From: Mike Firsel
Sent: Tuesday, March 30, 2021 1:52 PM
To: Hubbard, Sam
Cc: Perkins, Charles
Subject: RE: PC - Arlington 425
Attachments: Arlington 425 Parking Count Analysis.pdf

PARKING LEVEL DIAGRAM

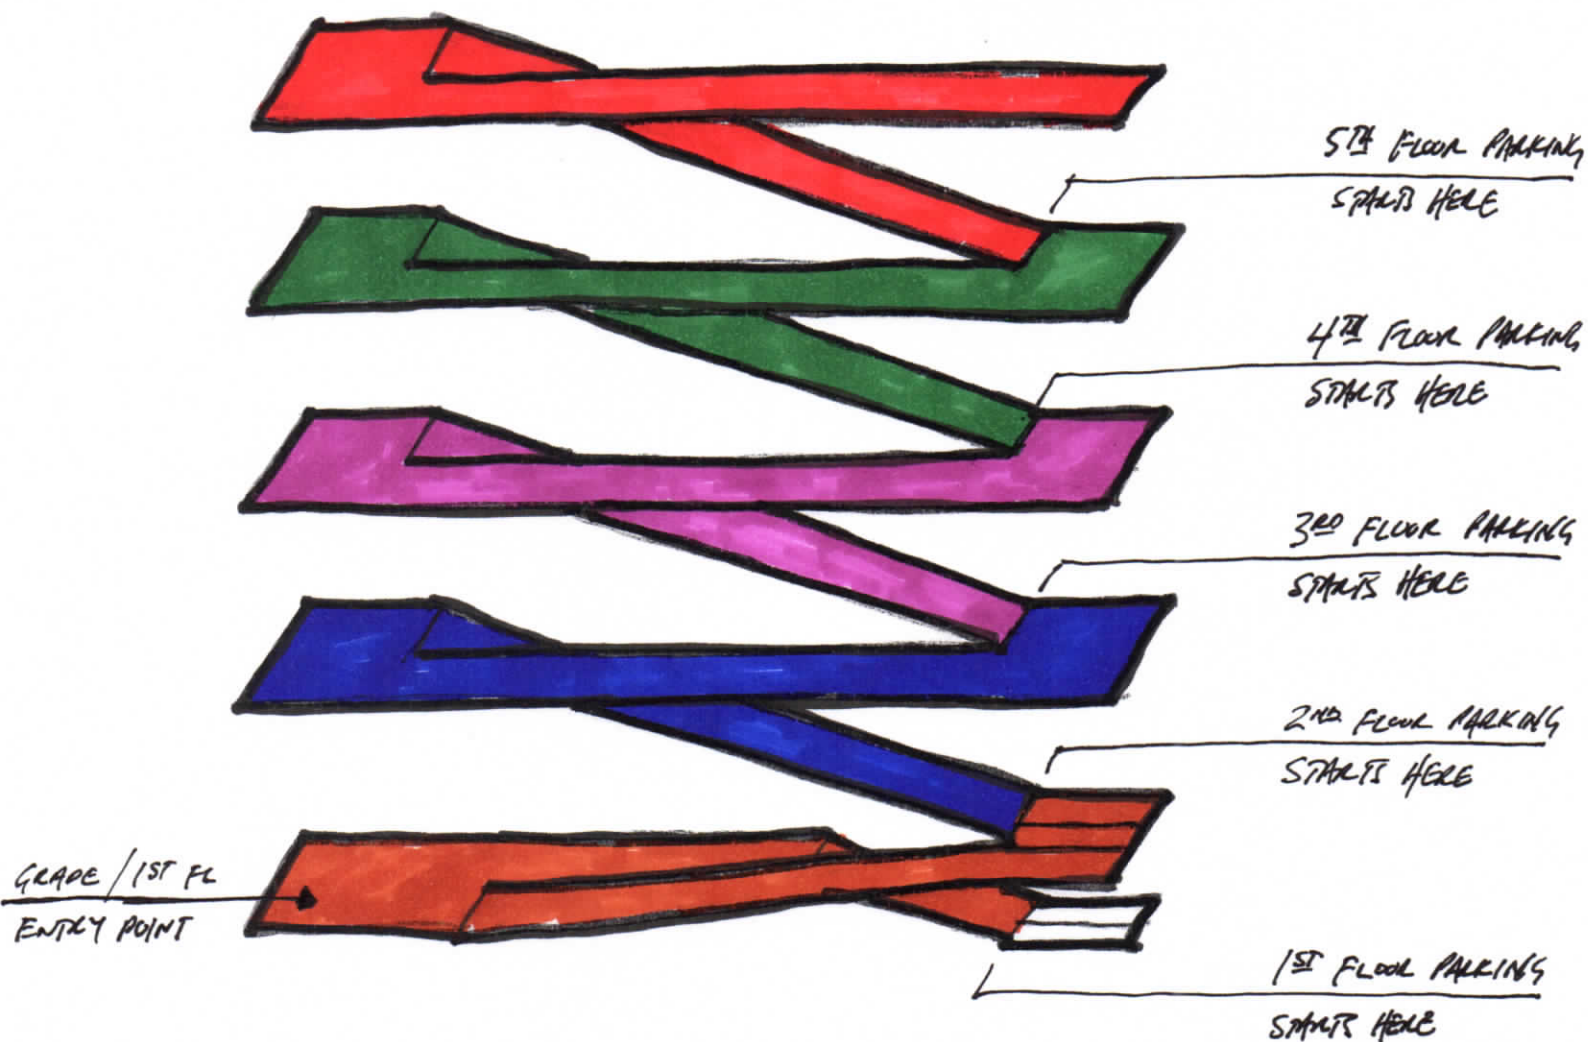
I am in receipt of the emails below. The plans as currently submitted, and that were submitted in 2019 when this project was approved, were described and formatted in the same way. Our architects, parking consultant and I were unable to understand the analysis done by Mr. Coon as shown on the email exhibit. Simply put, all vehicles are parked on the horizontal surface on each level, starting with the main level. The ramp takes the vehicle up to the next horizontal level, and so on. The first level truly has 75 surface level parking stalls that do not form any part of a ramp and are not double-counted.
